UNITED STATES PATENT AND TRADEMARK OFFICE

APPLICATION NO.	FILING DATE	FIRST NAMED INVENTOR	ATTORNEY DOCKET NO.	CONFIRMATION NO.
09/347,845	09/30/1999	YI YANG	243/079	4401

Office Action Summary

DETAILED ACTION

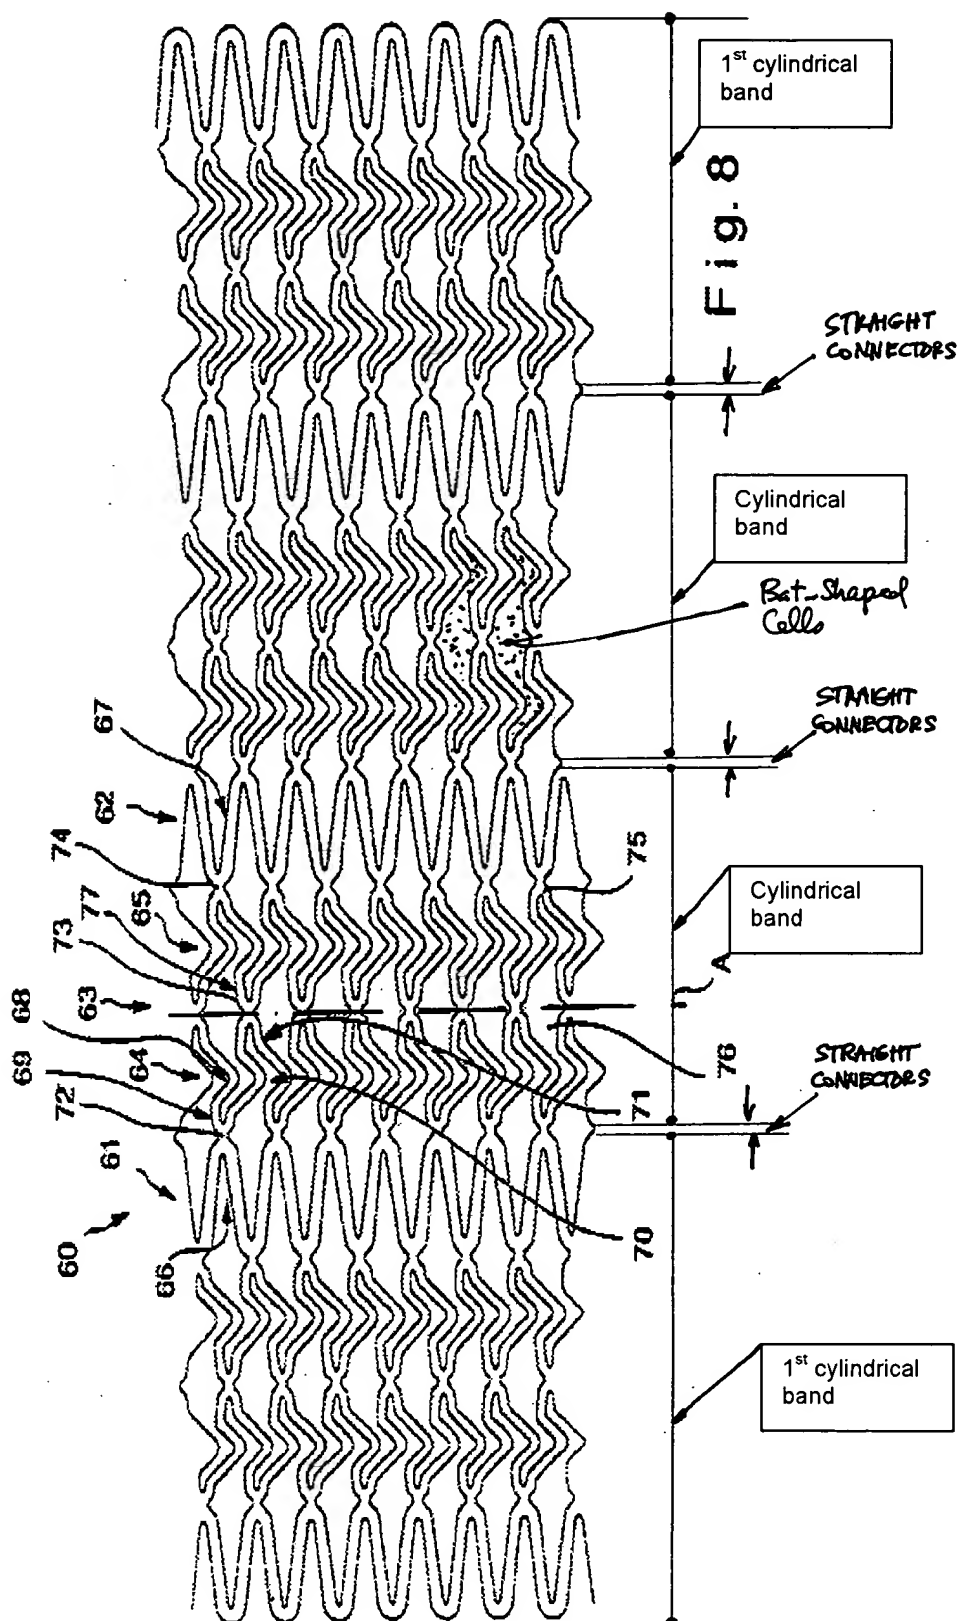
As to claims 1, 3-4, 8-11, and 24-25, VON OEPEN (Fig. 8 and see column 1, lines 36-39, VON OEPEN) discloses a **non-sinusoidal** zigzag pattern tubular stent (60) expandable from a contracted condition for easy introduction of the stent into a body lumen (a blood vessel) to an enlarged condition for supporting and keeping the body lumen (the blood vessel) open. Inherently, the stent is biased from a contracted condition either by a balloon or by a self-expanding property of the stent material towards an enlarged condition (as recited in claims 4, 24-25) to support the body lumen. The stent comprises:

- **A central portion consists essentially of a series of cylindrical bands, each band comprises a generally non-sinusoidal zigzag pattern of diagonal elements having generally arcuate shapes, arbitrarily assigned either a clockwise or counter clockwise orientation (please, see Von Oepen's Fig. 8 reproduced on page 5).**

- A plurality of straight and short or long connectors (I-shaped labeled as elements 66, 67) extending substantially parallel to the longitudinal axis of the stent. Notice that in a contracted configuration during deployment of the stent, connectors 66, 67 are squeezed closed one to each other and connectors 66, 67 are substantially parallel to the longitudinal axis of the stent.
- The short longitudinal connectors have a longitudinal dimension substantially smaller than a longitudinal dimension of the diagonal elements (as recited in claim 9). The diagonal elements comprise 1st and 2nd generally straight portions having 1st ends connected to preceding and succeeding diagonal elements and 2nd ends being connected together (as recited in claim 10).
- The diagonal elements of each cylindrical band are out of phase with any adjacent cylindrical band (as recited in claim 11).

As to claims 12-15 and 17-22, VON OEPEN (Fig. 8 as reproduced and shown on page 5 of this paper; see column 1, lines 36-39, VON OEPEN) discloses a tubular stent (60) comprising:

- A central portion consist essentially of a plurality of bat-shaped cells formed from **non-sinusoidal** cylindrical bands each cell having a head region, a tail region and opposing curved wing regions. The central portion consists essentially of a plurality of bat-shaped cells because there are a majority of bat-shaped cells in the central portion.
- A plurality of **straight short and long** connectors (I-shaped) extending substantially parallel to a longitudinal axis (as recited in claims 12 and 15) and **connecting each of the adjacent cells**. Notice that in a contracted configuration during deployment of the

- The head and tail regions are aligned about the circumference of the stent, the wing regions have a generally V-shaped extending longitudinally away from the head and tail regions (as recited in claim 13).

- The cells are arranged sequentially about the circumference, thereby defining a cylindrical band (as recited in claim 14).
- The wing regions are defined by 1st and 2nd arcuate members, the 1st and 2nd arcuate members comprising a pair of generally straight portions connected to one another by a curved portion, and the curved portion defines an apex of the "V" shape curved wing regions, the apices all pointing substantially in a single direction (as recited in claims 17-18).

- The head regions and tail regions are defined by longitudinal connectors (I-shaped connectors), one of the straight portions of each of the first and second arcuate members is substantially shorter than the other generally straight portion of the respective arcuate member, and the longitudinal connectors define the tail region also define the head region of an adjacent cell (as recited in claims 19-21).

- The connectors comprise a longitudinal connector (V-shaped connector) extending between a wing region of a first cell and a wing region of an adjacent cell (as recited in claim 22).

The claims as filed in the amendment on 4/08/2004 under 37 CFR 1.131 have been carefully considered. However, the claims are still read on Fig. 8 of Von Oepen-'747 as indicated in the above rejection.
